**Director's Report**

Project Name: Lakepointe  
 Description: Final site plan and PDA re-approval  
 Date on Agenda this packet pertains to: August 15, 2024

**RE: Lake Pointe – Final Site Plan and Final Engineering Plan –7<sup>th</sup> Review**

**RE: Lake Pointe – Final Site Plan Backcheck #4  
Parcel Number 12-36-177-003**

**FRONT ELEVATION**  
 SCALE: 1/4"=1'-0"

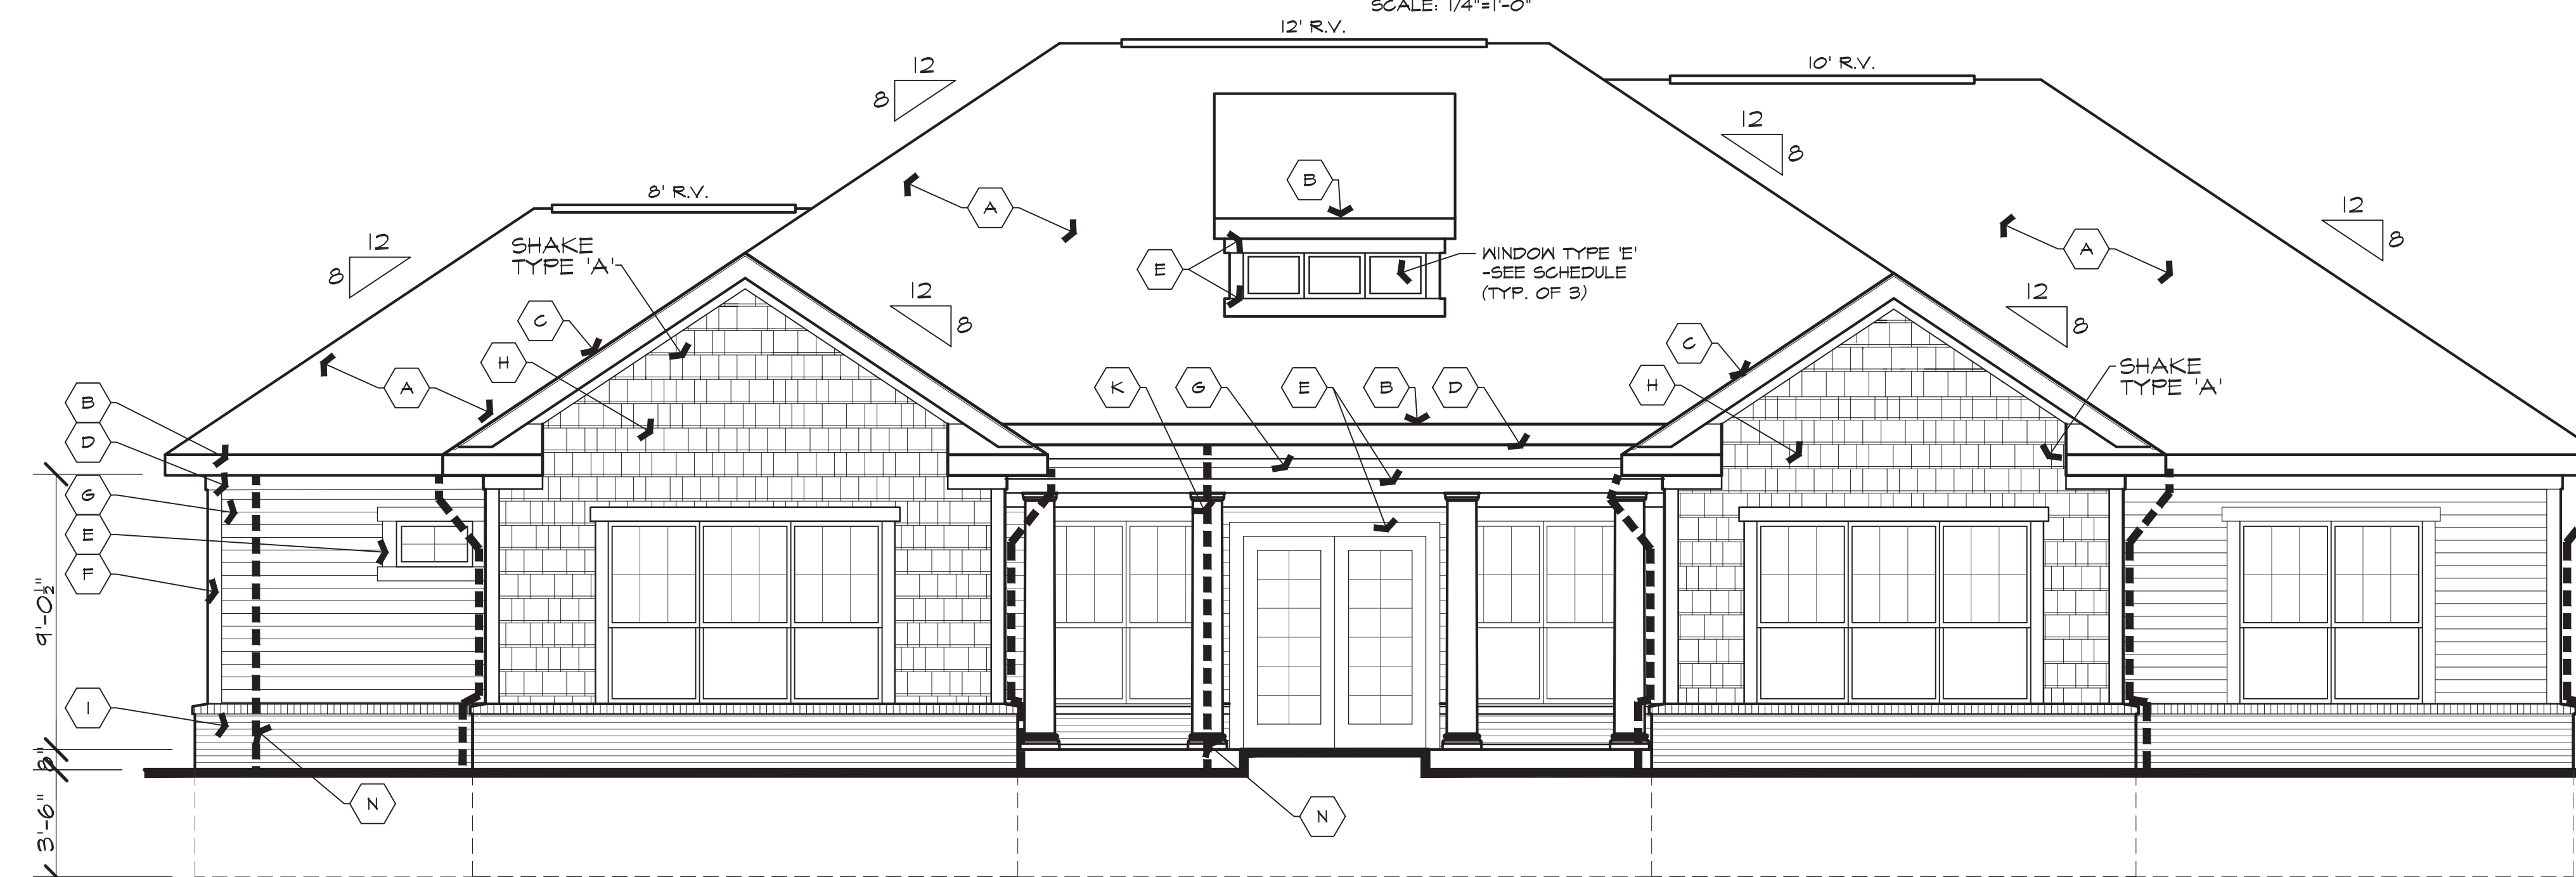
- As stated in previous correspondence (dated February 22, 2021), **elevations and building material details shall be provided for the clubhouse building.** (Comment addressed. Community building elevations have been provided).
